**TOWN OF NEWBURGH  
PLANNING BOARD  
TECHNICAL REVIEW COMMENTS**

**PROJECT: HUGGINS II SUBDIVISION & LOT LINE CHANGE**  
**PROJECT NO.: 14-23**  
**PROJECT LOCATION: SECTION 34, BLOCK 2, LOTS 24 & 90**  
**PROJECT REPRESENTATIVE: TALCOTT ENGINEERING**  
**REVIEW DATE: 26 NOVEMBER 2014**  
**MEETING DATE: 4 DECEMBER 2014**

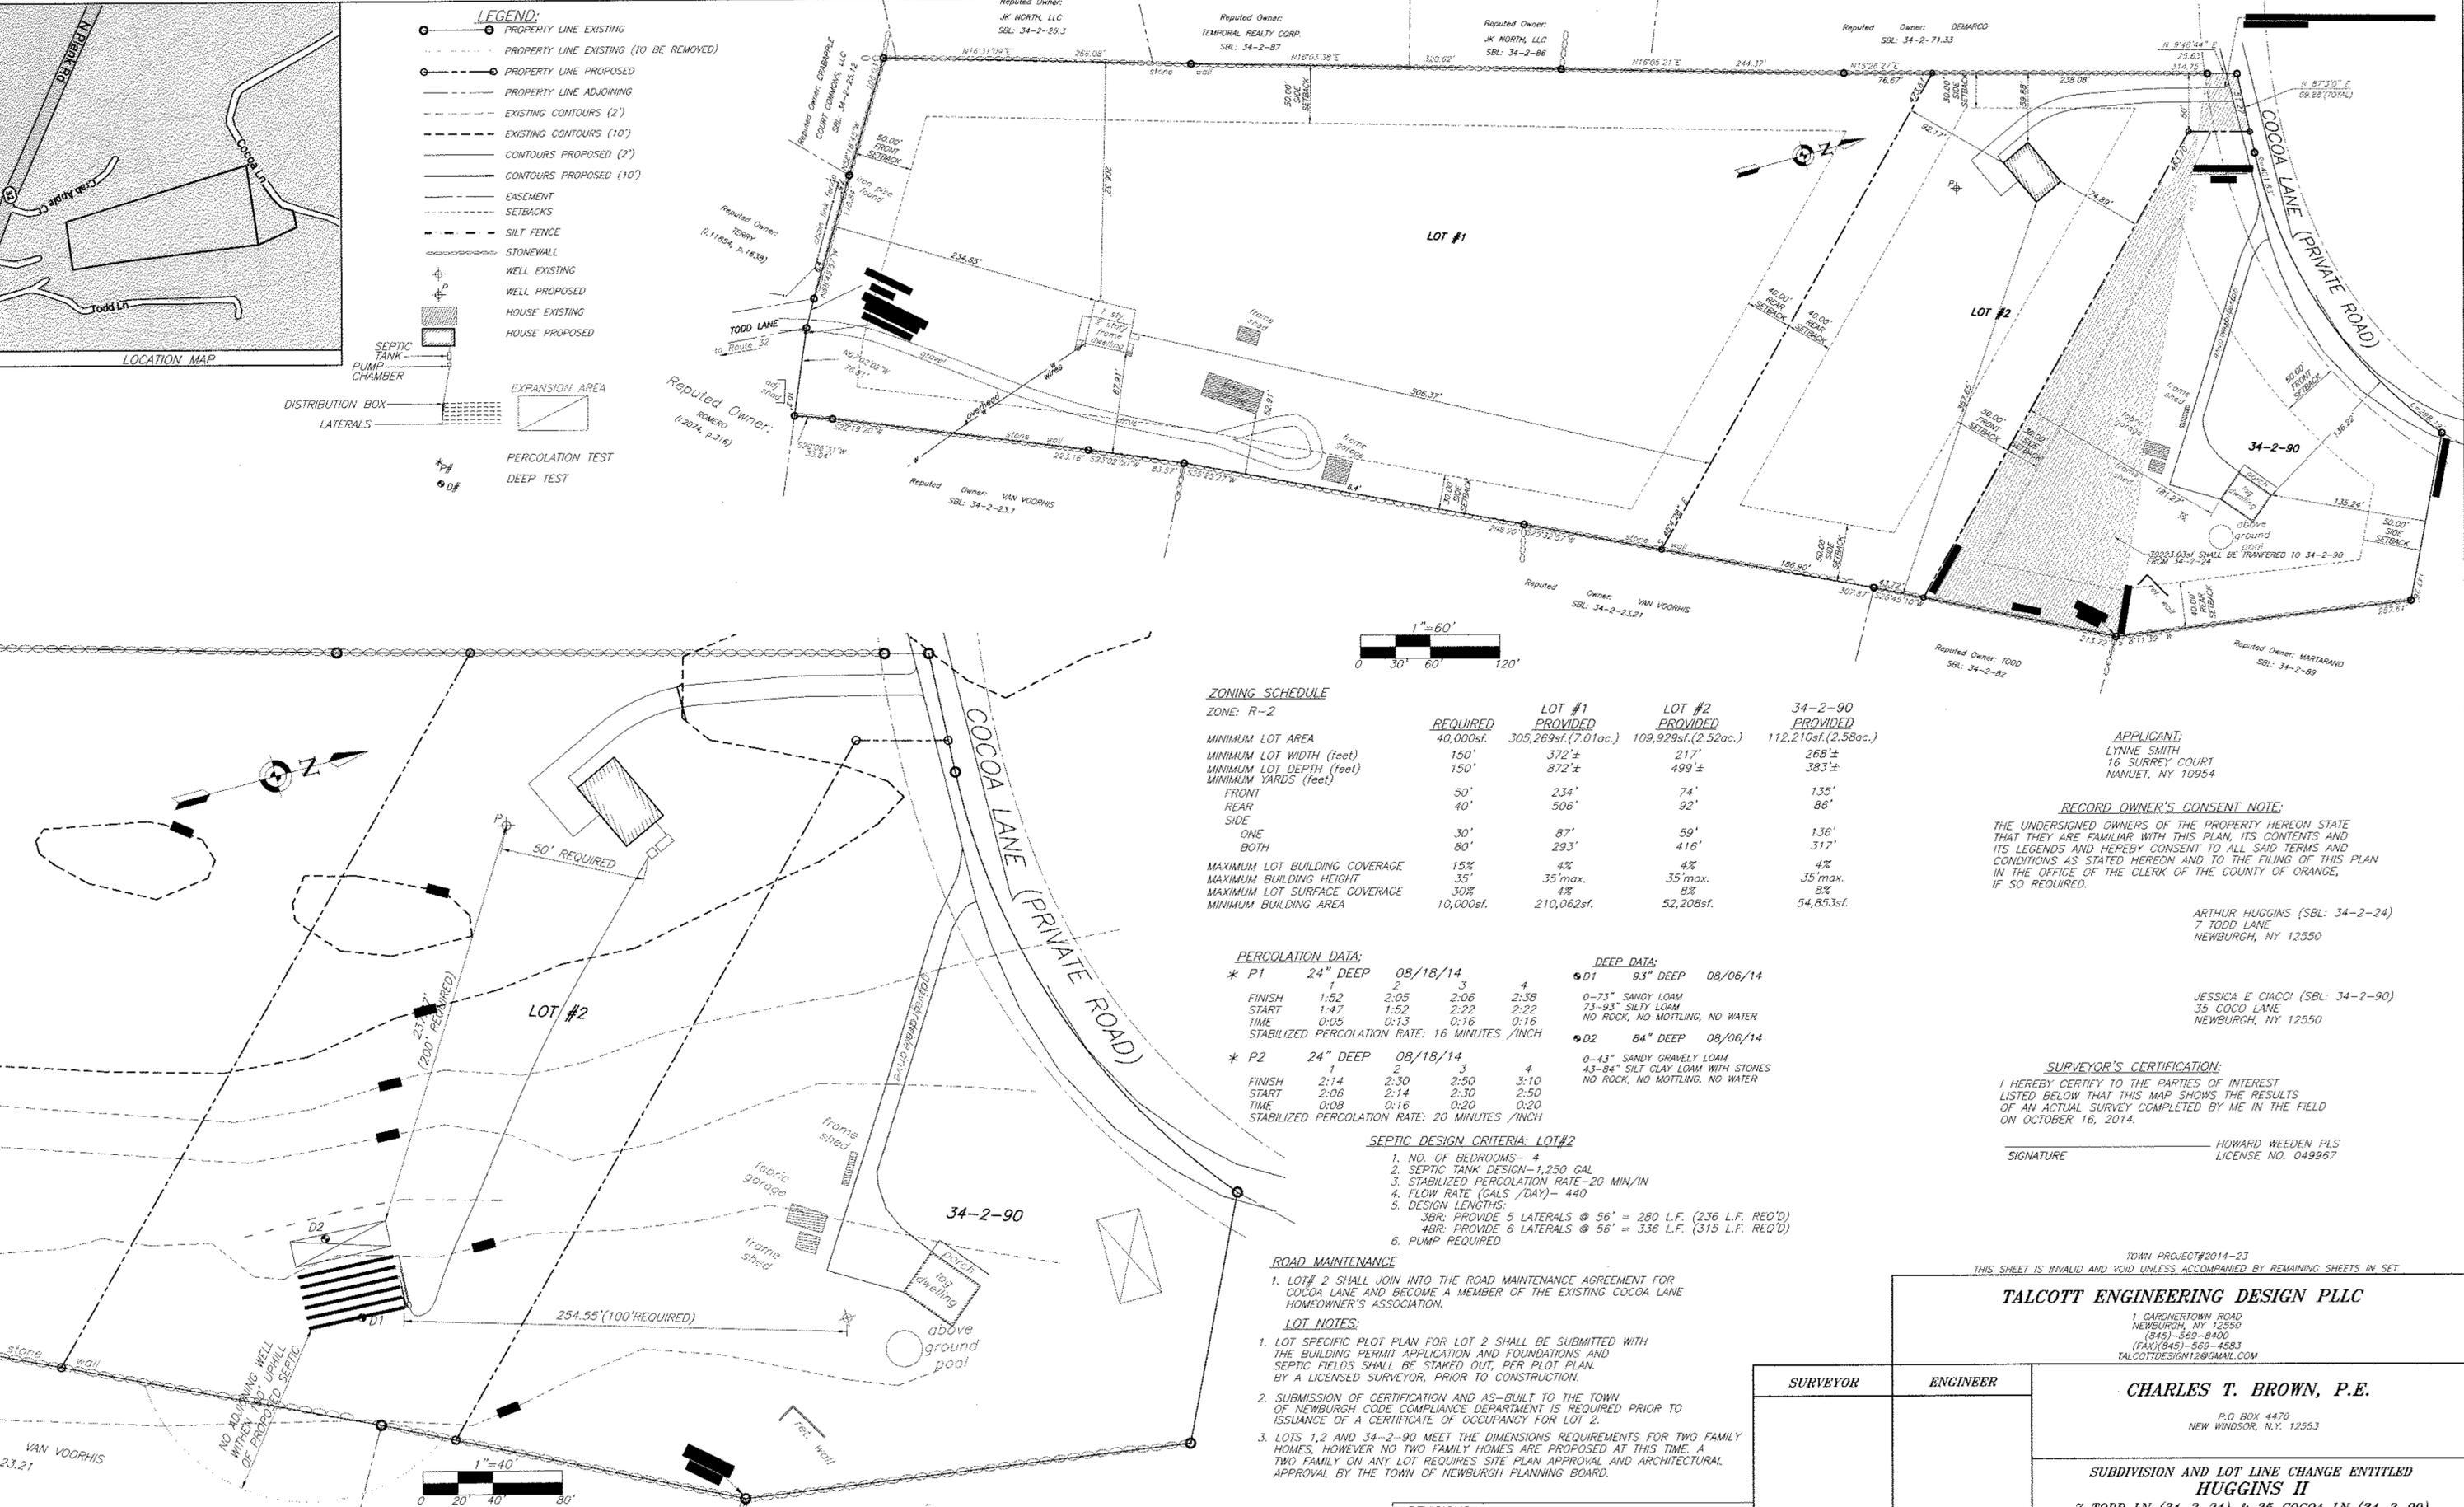
1. Plans have been revised to eliminate the previously proposed flag lot extension from lot 1 to Cocoa Lane. The previous flag lot extension would have enabled re-subdivision of lot 1.
2. The Cocoa Lane private road access and maintenance agreement should be submitted for Mike Donnelly's review allowing the additional lot to utilize the private roadway.
3. Orange County Planning has responded with a local determination, no advisory comments.
